গণপ্রজাতন্ত্রী বাংলাদেশ সরকার
শ্রম ও কর্মসংস্থান মন্ত্রণালয়
কলকারখানা ও প্রতিষ্ঠান পরিদর্শন অধিদপ্তর

ক্যাপ পর্যবেক্ষণের তথ্য

কারখানার নাম	ওয়েল টাচ এ্যাপারেলস লিঃ
ঠিকানা	234/1, Kochukhet, Vasantek, Mirpur, Dhaka-1206.
কারখানার কোড	DHK629
কালার কোড	
মূল্যায়নের ধরণ: কাঠামোগত মূল্যায়ন	পর্যবেক্ষণের তারিখ: ০৫-০৪-২০২৩
১. পর্যবেক্ষণ

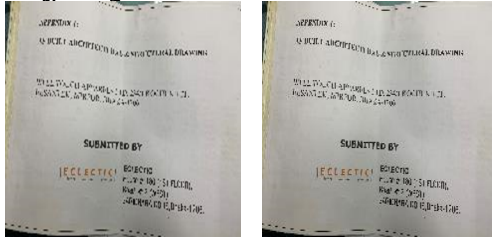
পরিদর্শন পর্যবেক্ষণ	There are 20 additional columns irregularly constructed, marked in the following layout plan, which seem to be illogical.
ক্যাপ আইটেম ক্যাটাগরি

কার্যক্রম	Building engineer to check and verify that the additional columns, existing building frame has sufficient capacity to carry factory imposed load.
সুপারিশের ভিত্তিসূত্র	
কারখানার কার্যক্রম	Building engineer will check load carrying capacity of building.
অগ্রাধিকার	৬ সপ্তাহ
চূড়ান্ত সময়সীমা	২১-০৯-২০১৬
সংশোধিত সময়সীমা	০১-০১-১৯৭০
অগ্রগতির অবস্থা	শুরু হয়নি
মন্তব্য	06/07/2020: This issue is related to DEA. Factory management appoint a consultant (ECLECTIC) for DEA. DEA work process is ongoing. 03.11.2020: DEA is not submitted yet. 01.02.2021: DEA work has been not started yet. 18/08/2021: There was no DEA & structural analysis available on site. 10/08/2022: DEA report should be prepared and submitted to DIFE as soon as possible. 05/04/2023: DEA report should be prepared and submitted to DIFE as soon as possible.

কার্যক্রম	Building engineer to assess the building structure with regard to lateral wind and seismic resistance.
সুপারিশের ভিত্তিসূত্র	
কারখানার কার্যক্রম	Engineer will check the lateral stability of the building.
অগ্রাধিকার	
চূড়ান্ত সময়সীমা	২১-০৯-২০১৬
সংশোধিত সময়সীমা	-
অগ্রগতির অবস্থা	শুরু হয়নি
মন্তব্য	06/07/2020: This issue is related to DEA. Factory management appoint a consultant (ECLECTIC) for DEA. DEA work process is ongoing. 03.11.2020: DEA is not submitted yet. 01.02.2021: DEA work has been not started yet. 18/08/2021: There was no DEA & structural analysis available on site. 10/08/2022: DEA report should be prepared and submitted to DIFE as soon as possible. 05/04/2023: DEA report should be prepared and submitted to DIFE as soon as possible.

কার্যক্রম	Carry out any structural alterations as advised by the Structural engineer.
সুপারিশের ভিত্তিসূত্র	
কারখানার কার্যক্রম	Proper action will be taken by the Engineer.
অগ্রাধিকার	
চূড়ান্ত সময়সীমা	০৯-০২-২০১৭
সংশোধিত সময়সীমা	০১-০১-১৯৭০
অগ্রগতির অবস্থা	শুরু হয়নি
মন্তব্য	06/07/2020: This issue is related to DEA. Factory management appoint a consultant (ECLECTIC) for DEA. DEA work process is ongoing. 03.11.2020: DEA is not submitted yet. 01.02.2021: DEA work has been not started yet. 18/08/2021: There was no DEA & structural analysis available on site. 10/08/2022: DEA report should be prepared and submitted to DIFE as soon as possible. 05/04/2023: DEA report should be prepared and submitted to DIFE as soon as possible.

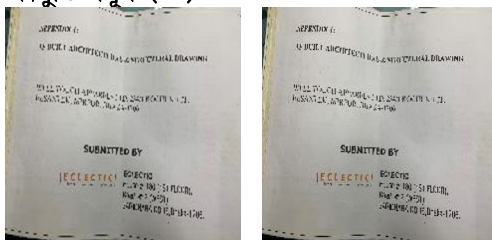
পরিদর্শন পর্যবেক্ষণ	Undocumented additional storey has been observed in the Building.
ক্যাপ আইটেম ক্যাটাগরি

কার্যক্রম	The Building Engineer shall provide calculations showing the structural adequacy of all columns taking into account any additions to the existing structure, the loading plans and as built structure.
সুপারিশের ভিত্তিসূত্র	
কারখানার কার্যক্রম	Structural adequacy of the building will be checked by the Engineer.
অগ্রাধিকার	৬ সপ্তাহ
চূড়ান্ত সময়সীমা	২১-০৯-২০১৬
সংশোধিত সময়সীমা	০১-০১-১৯৭০
অগ্রগতির অবস্থা	চলমান
মন্তব্য	06/07/2020: This issue is related to DEA. Factory management appoint a consultant (ECLECTIC) for DEA. DEA work process is ongoing. 03.11.2020: DEA is not submitted yet. 01.02.2021: DEA work has been not started yet. 18/08/2021: There was no DEA & structural analysis available on site but as built architectural & structural drawing were available on site. 10/08/2022: DEA report should be prepared and submitted to DIFE as soon as possible. as built architectural & structural drawing were found during inspection date. 05/04/2023: DEA report should be prepared and submitted to DIFE as soon as possible. as built architectural & structural drawing were found during inspection date.

কার্যক্রম	Building Engineer to survey and prepare as-built drawings for additional structure.
সুপারিশের ভিত্তিসূত্র	
কারখানার কার্যক্রম	All drawings will be prepared by the Engineer.
অগ্রাধিকার	
চূড়ান্ত সময়সীমা	০৯-০২-২০১৭
সংশোধিত সময়সীমা	০১-০১-১৯৭০
অগ্রগতির অবস্থা	চলমান
মন্তব্য	06/07/2020: As built drawing is completed and submitted to DIFE. 03.11.2020: As built structural and architectural drawing has been found on site. 01.02.2021: As built structural and architectural drawing has been found on site. 18/08/2021: As built architectural & structural drawing were available on site 10/08/2022: DEA report should be prepared and submitted to DIFE as soon as possible. As built architectural & structural drawing were found during inspection date.

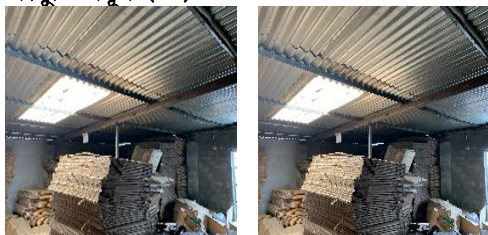
পরিদর্শন পর্যবেক্ষণ	Non-engineered lightweight shed has been found in the roof top. The shed is not stable enough against lateral loading, connections are not bolted properly, and member size seems to be inadequate.
ক্যাপ আইটেম ক্যাটাগরি

কার্যক্রম	Building engineer to assess light weight roof structure and confirm its ability to withstand all wind loading pressure suctions and uplift forces.
সুপারিশের উত্থাসূত্র	
কারখানার কার্যক্রম	Engineer will assess the capacity and stability of the roof shed.
অগ্রাধিকার	৬ সপ্তাহ
চূড়ান্ত সময়সীমা	২১-০৯-২০১৬
সংশোধিত সময়সীমা	০১-০৯-১৯৭০
অগ্রগতির অবস্থা	শুরু হয়নি
মন্তব্য	06/07/2020: This issue is related to DEA. Factory management appoint a consultant (ECLECTIC) for DEA. DEA work process is ongoing. 03.11.2020: This shed is not removed yet. 01.02.2021: This shed is not removed yet. 18/08/2021:On 18/08/2021:There was no DEA & structural analysis available on site. 10/08/2022: DEA report should be prepared and submitted to DIFE as soon as possible. Non-engineering shed was found on roof. 05/04/2023: DEA report should be prepared and submitted to DIFE as soon as possible. Non-engineering shed was found on roof.

কার্যক্রম	Building engineer to check the capacity and stability of the lightweight roofs and make any necessary alterations.
সুপারিশের উত্থাসূত্র	
কারখানার কার্যক্রম	Engineer will check the capacity and stability of the roof shed.
অগ্রাধিকার	
চূড়ান্ত সময়সীমা	০৯-০২-২০১৭
সংশোধিত সময়সীমা	০১-০৯-১৯৭০
অগ্রগতির অবস্থা	শুরু হয়নি
মন্তব্য	06/07/2020:This issue is related to DEA. Factory management appoint a consultant (ECLECTIC) for DEA. DEA work process is ongoing. 03.11.2020: This shed is not removed yet. 01.02.2021: This shed is not removed yet. 18/08/2021:On 18/08/2021:There was no DEA & structural analysis available on site. 10/08/2022: DEA report should be prepared and submitted to DIFE as soon as possible. Non-engineering shed was found on roof. 05/04/2023: DEA report should be prepared and submitted to DIFE as soon as possible. Non-engineering shed was found on roof.
